DESCRIPTIVE REPORT (HYDROGRAPHIC)

Type of Survey HYDROGRAPHIC
Field No. PE 40-2-75
Office No. H-9531

State NEW JERSEY
General Locality NEW YORK BIGHT
Locality OFF ASBURY PARK

SUBJECT: Quality Control Report for H-9531 (1975), New Jersey, New York
Bight, Off Asbury Park

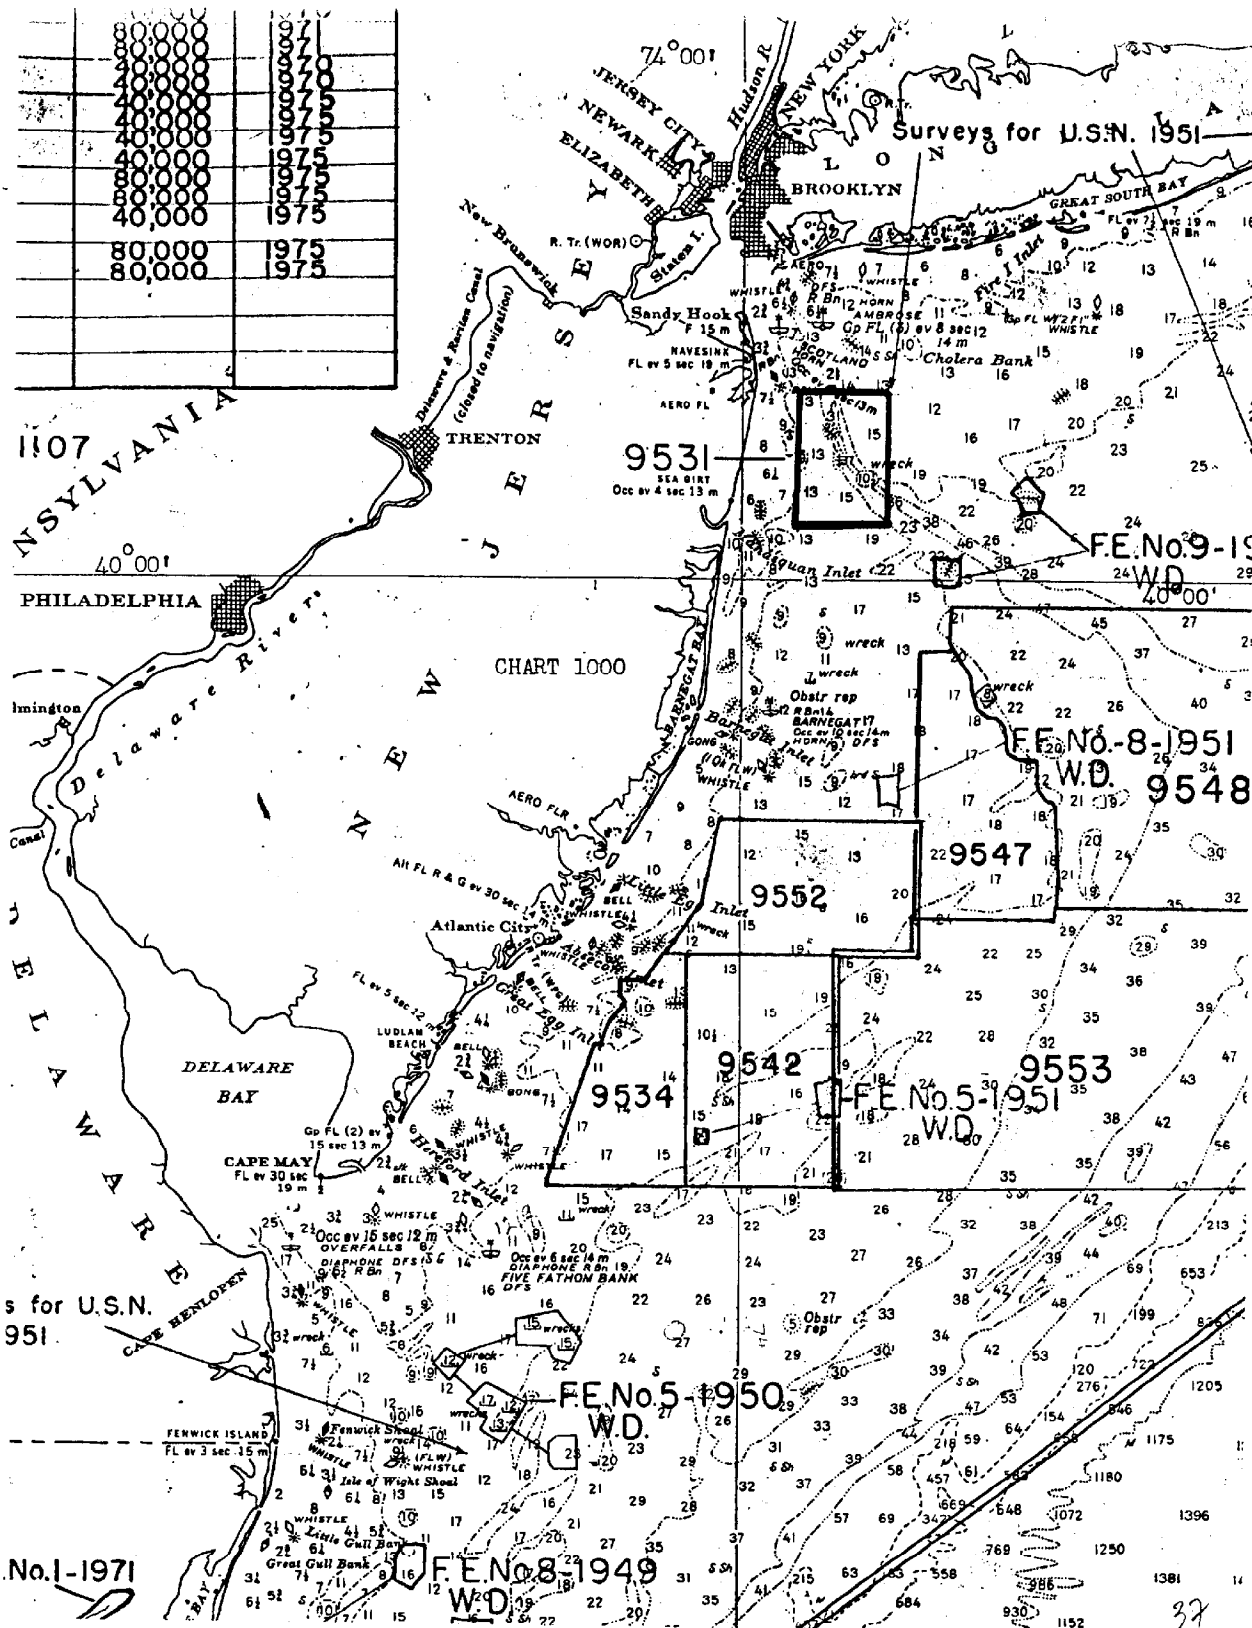
4. The reviewer failed to state that the prior surveys are superseded by the present survey. [See provisional manual - section 6.6(11).] Sections 5-A and 5-B of the Review Report are supplemented by the following:

The present survey is adequate to supersede the prior survey within the common area.
